SERVICE BULLETIN

No. 464A

Piper Aircraft Corporation

Inspection of Stabilator Torque Tube Bearing Block Attachment Fitting Rivets.

VIEW A-A: RIVET ALIGNMENT which may have resulted in rivet penetration:

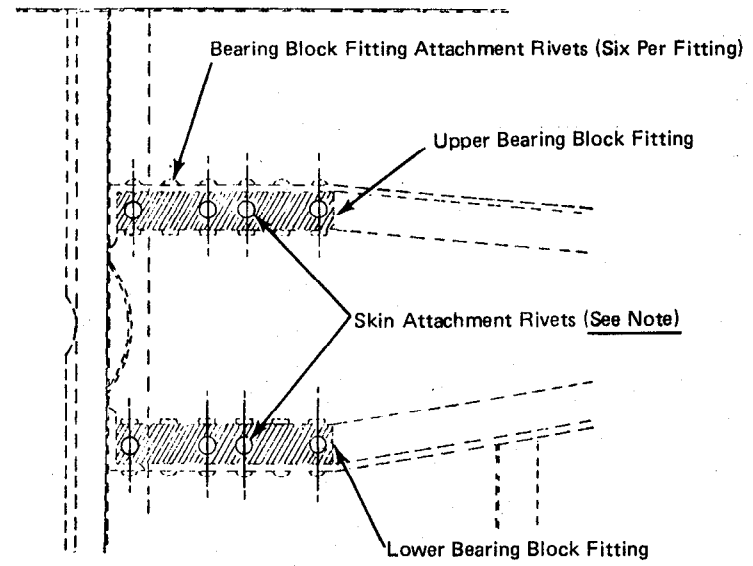
NOTE: All horizontal rivets, except the corner rivets, are incorrectly installed in this view as they are aligned with the vertical rivets. If more than two rivet alignments are evident in each fitting, it will be necessary to install Kit 760 835.
